STATE OF IDAHO  
DEPARTMENT OF WATER RESOURCES

PROOF OF BENEFICIAL USE

RE: Teton Springs Development  
DEQ#: 00-1-41

**Re: Sanitary Survey Results for the Teton Springs  
PWS # 7410033**

Fig. 3 – Well # 1 sanitary seal and conduit

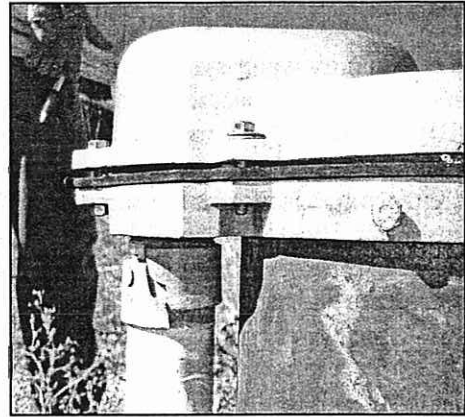
- 1) The well cap for Well # 1 was missing (2) bolts (Fig 3). The bolts must be installed in order to provide an adequate water tight seal to prevent contaminated water or other materials from entering the well in accordance with IDAPA 58.01.08.550.03.1.ii. which states: wells shall be cased and sealed in such a manner that surface water cannot enter the well
- 2) A well vent is required to be installed on well # 2 in accordance with IDAPA 58.01.08.550.03.k. which states: all wells...shall be vented with the open end of the vent screened and terminated downward at least (18) inches above the final ground surface.

- 3) The conduits that hold the electrical cables that attaches to the well # 1 (Fig. 3 and 11) and # 2 pump has come apart and must be repaired to prevent introduction of potential contaminants in accordance with IDAPA 58.01.08.550.03.1.ii.

**Fig. 6** – source sample tap

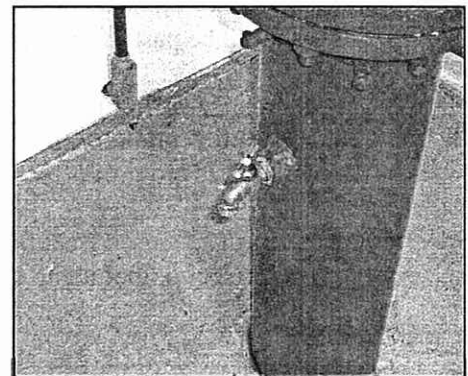
- 1) Both wells have “threaded” sample taps (**Fig. 6**) that need to either be equipped with an appropriate (approved) backflow device or the threads must be removed to create a smoothed-nosed connection. In accordance with IDAPA 58.01.08 550.03.g. which states: a smoothed-nosed sample tap shall be installed on the discharge line from every well... Any threaded taps installed in the well house must be equipped with an appropriate backflow device.

**Fig. 7 – pump to waste piping**

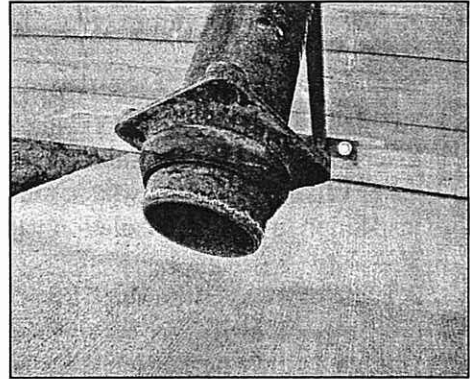
- 3) All discharge piping to daylight such as the pump to waste (**Fig. 7**) piping is required to be provided with an expandable metal screen within the pipe plus a weighted flapper valve to properly protect against the entrance of potential contamination in accordance with IDAPA 58.01.08.550.08.e.

**Fig. 10 – tank hatch**

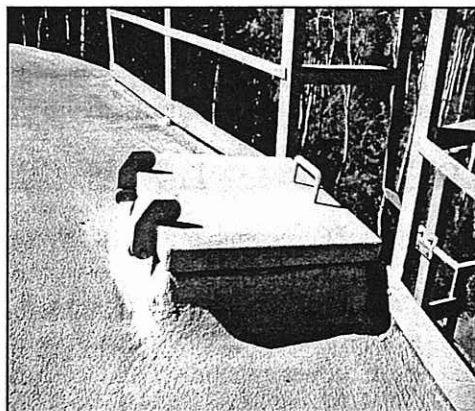
- 1) To avoid unauthorized entry and possible contamination, the hatch lid should be locked at all times in accordance to IDAPA 58.01.08.550.08.d. Manholes shall be fitted with an overlapping watertight locked cover (**Fig. 10**).
